Contract #: 04-0120F4Cty: SF/ALA Rte: 80 PM: 13.2/13.9File #: 69.25B**QUALITY ASSURANCE -- NON-CONFORMANCE REPORT****Location:** Changxing Island, Shanghai, P.R. China**Report No:** NCR-000279**Prime Contractor:** American Bridge/Fluor Enterprises, a JV**Date:** 21-May-2009**Submitting Contractor:** Zhenhua Port Machinery Company, Ltd (ZPMC), Changxing Island**NCR #:** ZPMC-0253**Type of problem:**

**Reference Description:** Heat Straightening Without Approved Procedure, Crossbeam CB7**Description of Non-Conformance:**

**Subject:** NCR No. ZPMC-0253

## NCR PROPOSED RESOLUTION

Heat Straightening Record (HSR1)

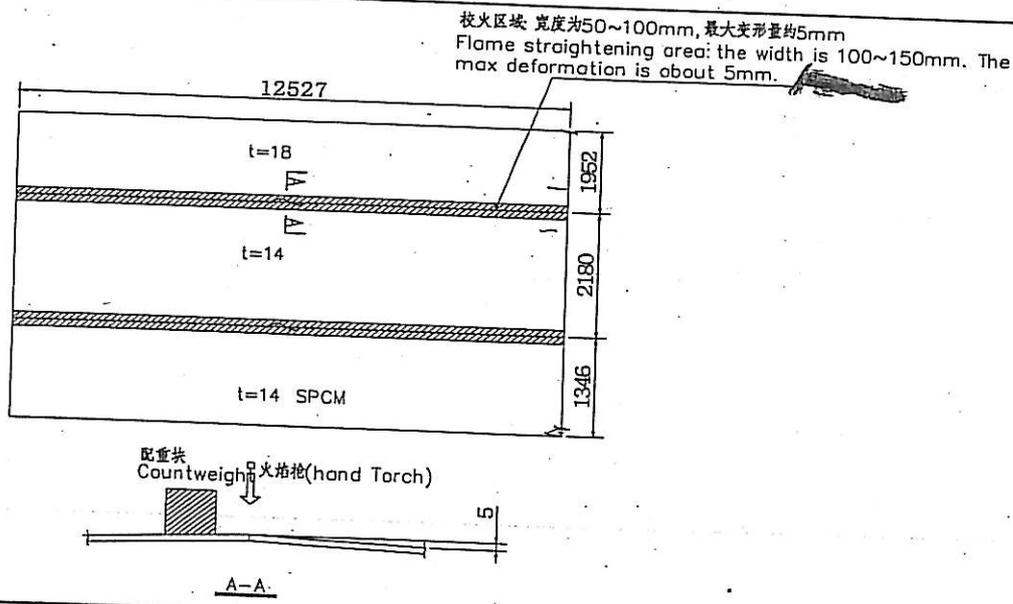
情况描述 Description of Condition

Cause 原因: Welding distortion 焊接变形  
 Type of Defect 缺陷类型: Welding distortion 焊接变形  
 Inspection Method 检查方法: Visual 目检

缺陷去除方法 (Defect Removal Method): Flame Straightening by oxygen acetylene  
 后续 NDE (Post-Removal NDE): After finishing heat straightening, the weld of the heat area shall perform NDT according to the approved shop drawing.  
 纠正措施 (Corrective Action(s)): Control current, voltage and weld speed according to relevant WPS. If necessary anti-deformation or hold down device can be added.  
 实施次数 (Number of application): 1~3  
 最高温度 (Maximum temperature): <600°C
